CONSTRUCTION ISSUES

Construction Issues

101 Issues sorted by **date identified**

TST-111-10 OPEN

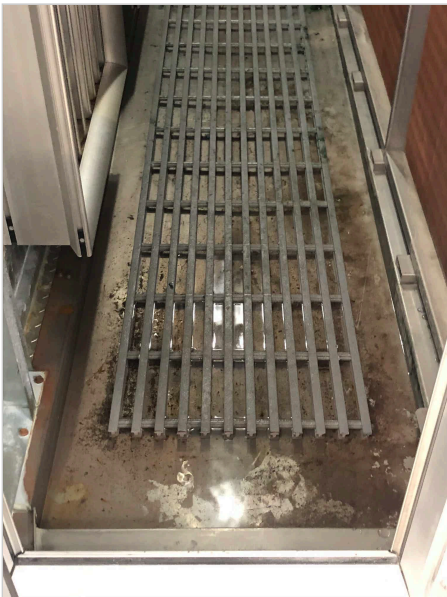
2 of the rubber stoppers on the door for the Return Fan air filter compartment have fallen off (currently on top of the RF disconnect box).
Internal connector of the stopper appears missing on both.

Not corrected as of Feb 25 field visit
